Item ID: D212-664-101

Item Name: Crosstube Fwd

DART AEROSPACE LTD	Work Order:	72259
Description: Crosstube High Fwd (205/212/412)	Part Number:	D212-664-101
Inspection Dwg: D212-664-141 Rev: D		Page 1 of 1

DRAWING NO. D212-664-141	TITLE XTUBE ASSY (205/212/412 HI FWD)	REV. D	DART AEROSPACE LTD ENGINEERING ORDER		D.E.O. NO. D212-664-141-D-1	SHEET NO. SHEET 1 OF 2	SCALE NTS
DRAWN	CHECKED	MFG. APPR.	APPROVED	DE APPR.			
DATE 11.04.07	DATE 11.04.11	DATE 11.04.12	DATE 11/04/12	DATE 11.04.12

**D212-664-141/-141B
ASSEMBLY DETAIL**

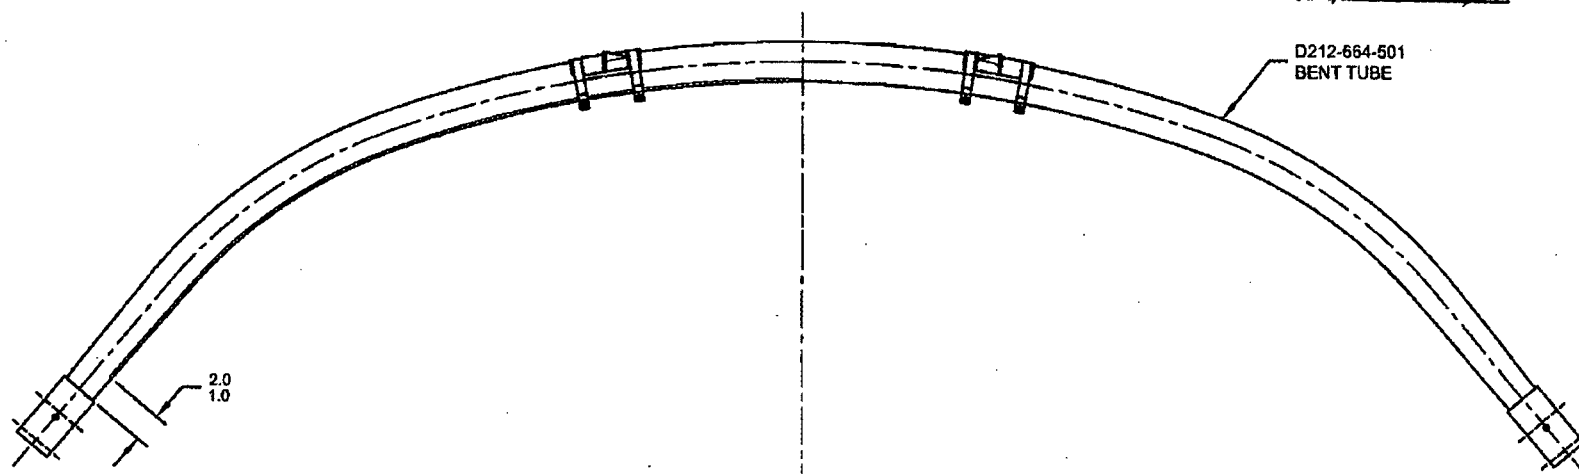
ADD AN INSPECTION WINDOW TO UNDERSIDE OF CROSSTUBE.

NOTES 2 OF SHEET 1 IS AMENDED AS FOLLOWS:

- 2) FINISH: CHEMICAL CONVERSION COAT PER DART QSI 005 4.1
PRIME INSIDE AND OUTSIDE PER DART QSI 005 4.2
MASK UNDERSIDE OF CROSSTUBE AS SHOWN (HATCHED AREA) AND
PAINT OUTSIDE PER DART QSI 005 4.2
REMOVE MASKING AND APPLY CLEAR COAT

- 2) FINISH: CHEMICAL CONVERSION COAT PER DART QSI 005 4.1
PRIME INSIDE AND OUTSIDE PER DART QSI 005 4.2
PAINT OUTSIDE PER DART QSI 005 4.2

MASK AREA PRIOR TO PAINTING,
REMOVE MASKING AFTER PAINT
AND APPLY CLEAR COAT

D2893-1 SUPPORT

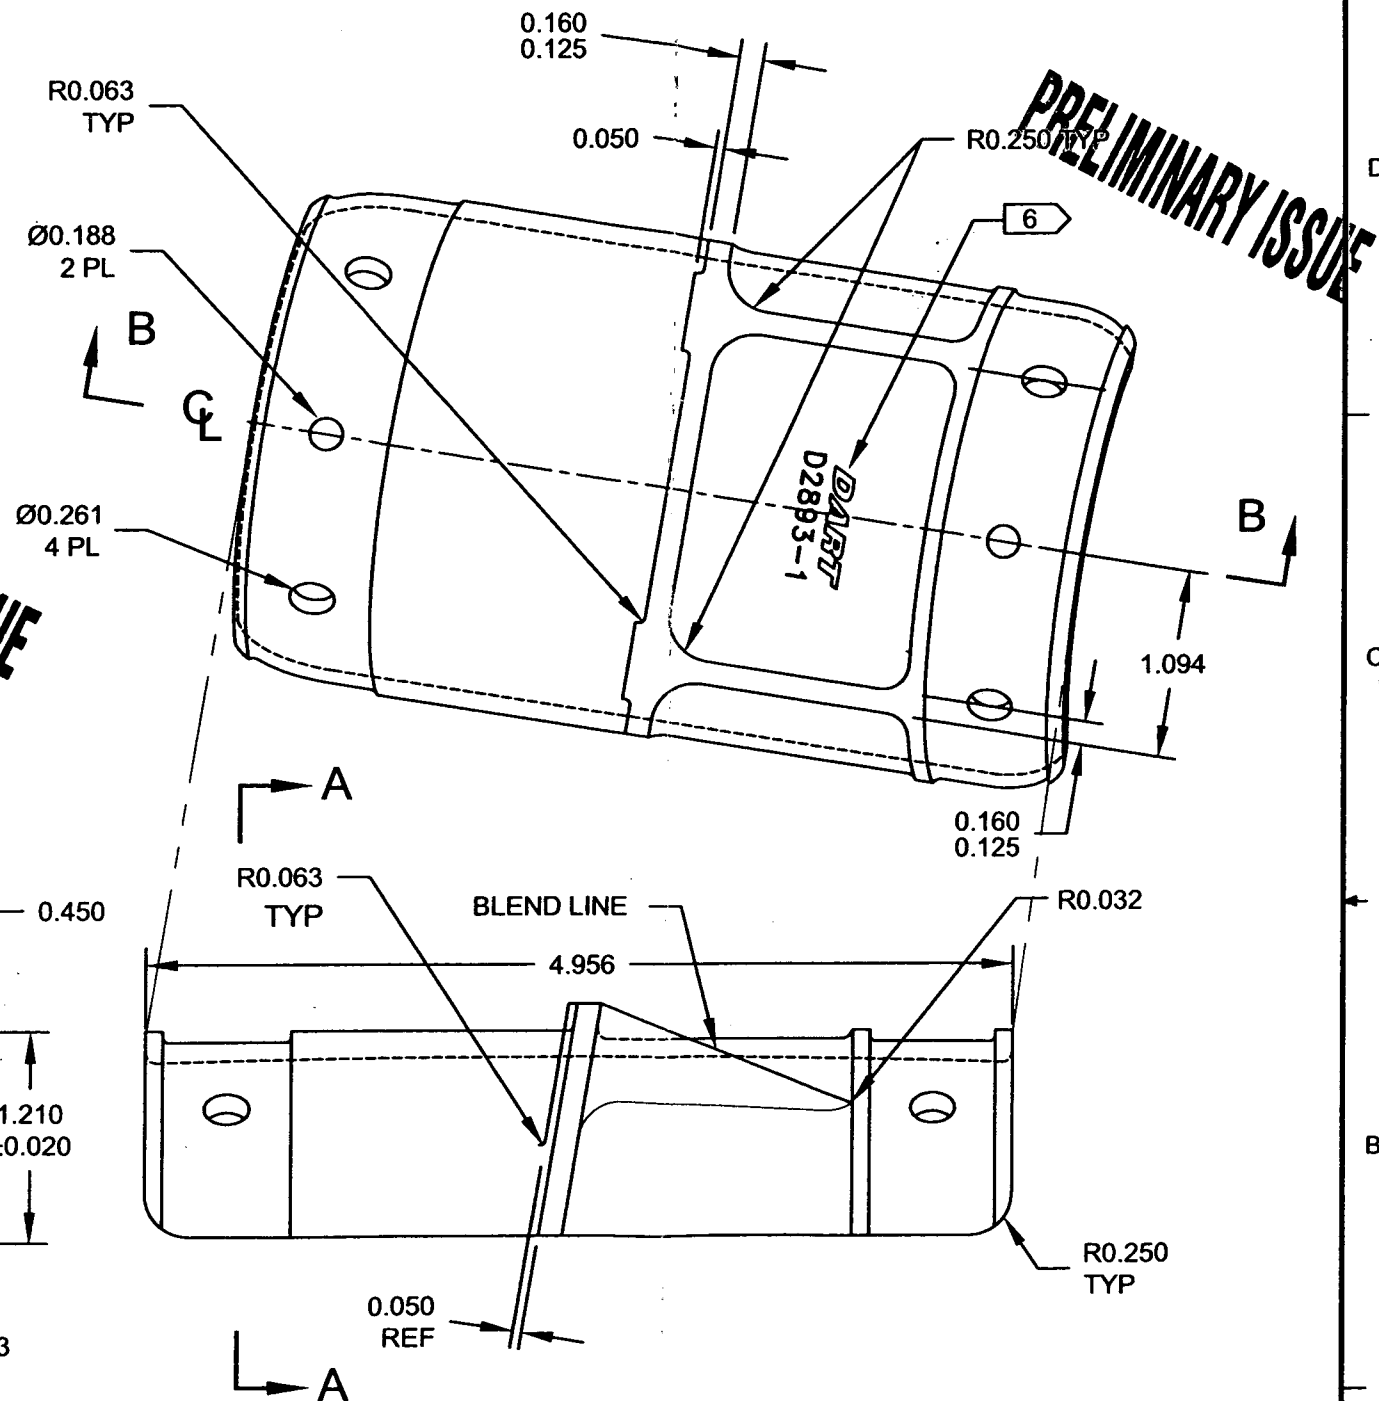
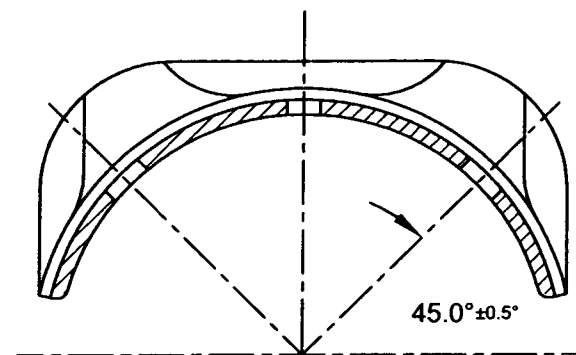
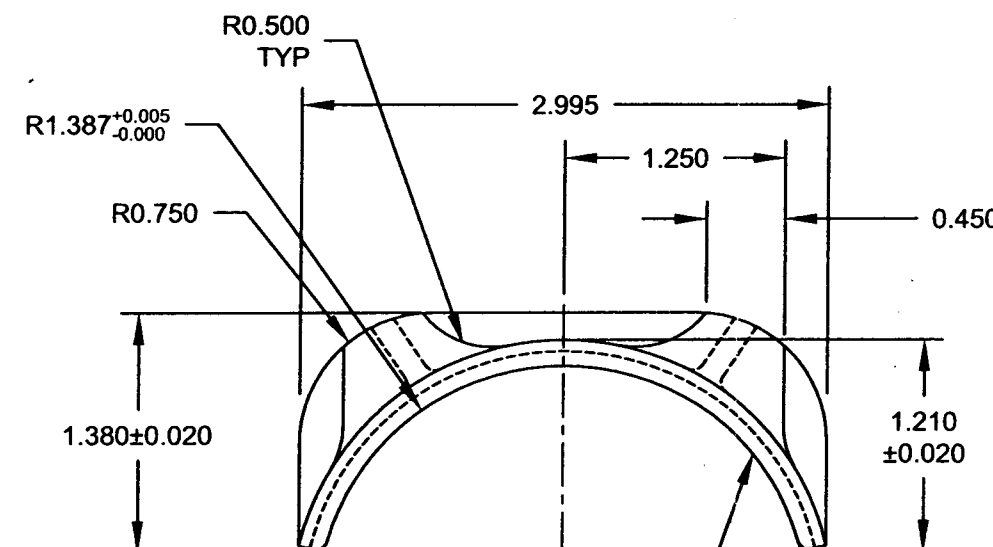
REPLACE MAGNOBOND WITH PROSEAL.

Item	Qty -141	Qty -141B	Part Number	Description
7	A/R	A/R	PROSEAL 890 B-2	SEALANT, AMS-S-8802 CLASS B-2

7	A/R	A/R	MAGNOBOND 6398	ROCKWELL SPECIFICATION RBO-120-023 ADHESIVE (TEXTRON/BELL SPEC. 299-947-100, TYPE II, CLASS 2 ADHESIVE)
---	-----	-----	----------------	---

- 12) TO INSTALL D2893-1 SUPPORT: ABRASE MATING SURFACE OF SUPPORT AND CROSSTUBE WITH 180-GRIT SANDPAPER AND REMOVE RESIDUE WITH MEK (OR EQUIVALENT). APPLY A 0.04" TO 0.07" THICK LAYER OF PROSEAL 890 CLASS B-2 (OR AMS-S-8802 CLASS B-2) SEALANT TO MATING SURFACE OF SUPPORT.
- 15) TORQUE CLAMPS 80 TO 100 IN-LB. ENSURE AT LEAST 1.5 THREADS SHOWING IN SAFETY AND THAT NUT HAS NOT BOTTOMED-OUT AFTER TORQUING. **PRIOR TO PACKAGING, RE-CHECK TORQUE ON CLAMPS AFTER PROSEAL 890 SEALANT HAS CURED FOR 72 HOURS.**

- 12) INSTALL D2893-1 SUPPORT USING 0.03" TO 0.06" THICK LAYER OF MAGNOBOND 6398 TO THE SURFACE OF D2893-1 THAT WILL BE IN CONTACT WITH THE CROSSTUBE PER QSI 015. LET CURE FOR 12 HOURS AFTER INSTALLATION AND PRIOR TO PACKAGING.
- 15) TORQUE CLAMPS 80 TO 100 IN-LB. ENSURE AT LEAST 1.5 THREADS SHOWING IN SAFETY AND THAT NUT HAS NOT BOTTOMED-OUT AFTER TORQUING.

ABRADE SURFACE WITH 400-GRIT SANDPAPER. REMOVE RESIDUE WITH MEK
(OR EQUIVALENT). APPLY 0.03" TO 0.05" THICK LAYER OF 3M SCOTCH-WELD 2216 B/A
ADHESIVE TO MATING SURFACE OF SUPPORT. ALLOW TO CURE FOR 24 HOURS.

C	RMV FINISH, ADD 3M 2216, ADD H925 MAT'L OPTION	CP	11.07.15
B	UPDATE DIMS AS MFG, PRIME INSIDE	PH	07.03.16
A	NEW ISSUE	CP	01.01.10
REV.	DESCRIPTION	BY	DATE
DESIGN	ASS	DART AEROSPACE LTD HAWKESBURY, ONTARIO, CANADA	
DRAWN	ASS		
CHECKED	ASS	DRAWING NO.	REV. C
MFG. APPR.	ASS	D2893	SHEET 1 OF 1
APPROVED	ASS	TITLE	SCALE
DE APPR.	ASS	Ø2.750 SUPPORT	NTS
DATE	11.07.15	COPYRIGHT © 2001 BY DART AEROSPACE LTD THIS DOCUMENT IS PRIVATE AND CONFIDENTIAL AND IS SUPPLIED ON THE EXPRESS CONDITION THAT IT IS NOT TO BE USED FOR ANY PURPOSE OR COPIED OR COMMUNICATED TO ANY OTHER PERSON WITHOUT WRITTEN PERMISSION FROM DART AEROSPACE LTD.
